Supporting Statement for Applications
[refs. DM/25/2654 and 2655]
Wykehurst House, nr Bolney RH17 5QQ

The Conservation Officer has requested further information, to enable their assessment of the proposals in the following categories. For each item, we have copied the information request and provided our detailed response below. These can be read with the attached documents which are cross-referenced in the text below.

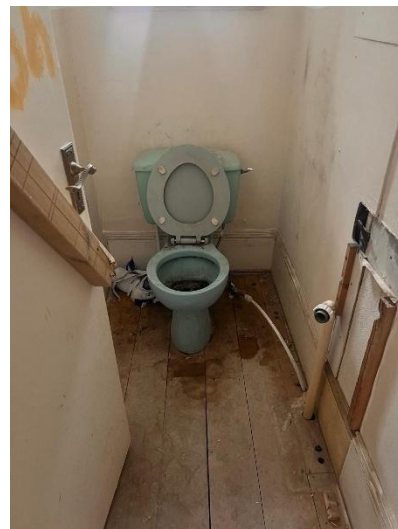
The submitted email from Mittens Plumbing and the accompanying Water Services plans are not sufficient for a full understanding of the work which has been undertaken, the justification for it, or its potential impact on historic fabric (it is understood that this aspect of the proposal is retrospective).

A more detailed condition report of the previously existing water system should be provided, alongside a detailed schedule of the new work which has been undertaken. Separate existing and proposed plans should be provided- it is not clear which we currently have in front of us, and no indication of changes to pipe routes etc. is given. The Heritage Statement should be expanded to give a more detailed consideration of the impact on the historic fabric of this work.

(Please also refer to the sections below, which interlink with this item, and include assessment of the impact on existing timber floors generally).

Modern plasterboard ceiling with new pipework run in void above.

Modern, harmful pipework addition

Examples of 70s plumbing additions including supplies and drainage tracking around rooms and penetrations through fabric.

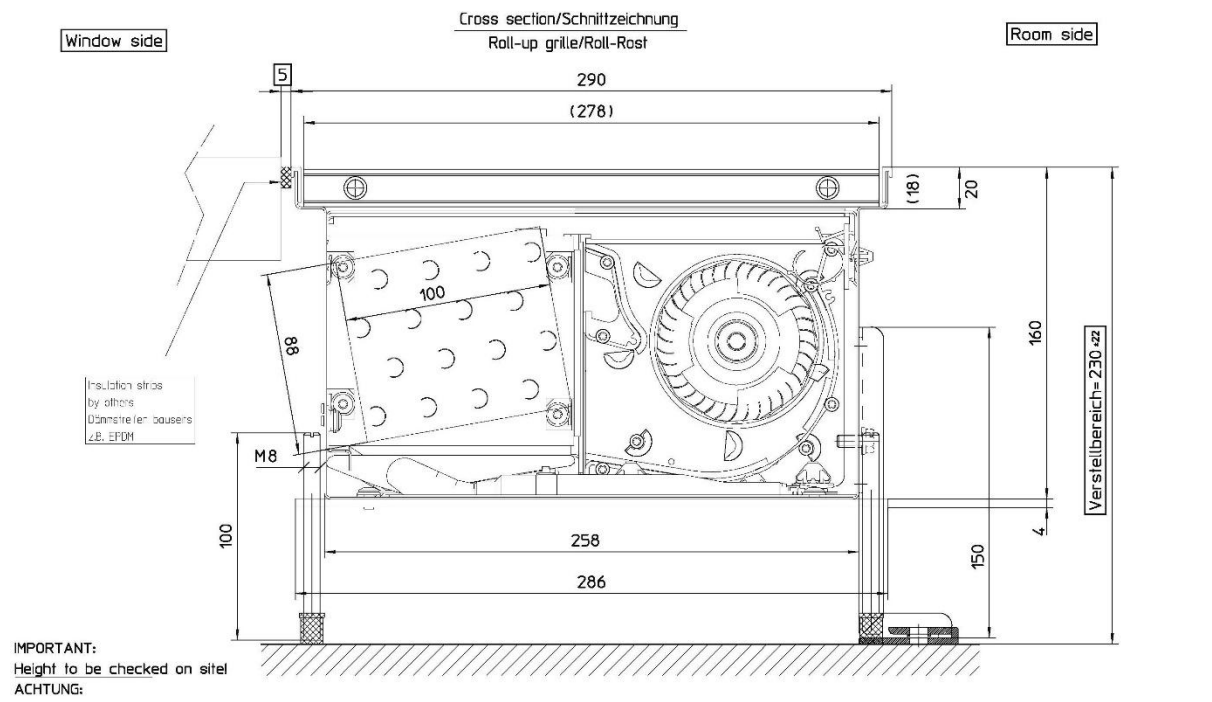
The information in this respect is inadequate. There is no indication of whether this work has already been undertaken or not. There is no detail beyond what appear to be plans of feeder pipes(?) at basement and ground floors of the extent or nature of the system, its relationship with the existing floor structures/finishes, or the extent of any impact on historic fabric. More detailed plans, including room plans and typical sectional details, should be provided, alongside a detailed methodology and impact statement.

We confirm that floor recessed trench heaters have NOT been installed and that this remains a proposal for officer consideration. In the section above, describing 'New Heating' generally, we outline the case for using trench heaters and that this is considered the least harmful method of introducing new heating sources into the 'principal' rooms – these being the rooms where much of the original design intent and detail is preserved, and are therefore also of greatest historic significance.

We attach below a detail of the proposed product, for consideration. The proposed method of installation involves the trimming and bridging of existing floor joists to accommodate the new trench heater box width. The grille itself is rolled into a floor rebated 'tray' so that only the grille is visible inside a fine outline (the tray lip).

The adjacent photograph shows exploration of the existing dining room floor void, revealing modern timber supports below and a void of sufficient depth to hold the proposed trench heater product. Only the grille being visible, flush to the floor.

The floor joists below will be 'trimmed' locally to provide space for the heater, requiring one joist to be cut-out, with the ends re-supported by perpendicular double timbers, spanning between the remaining joists.
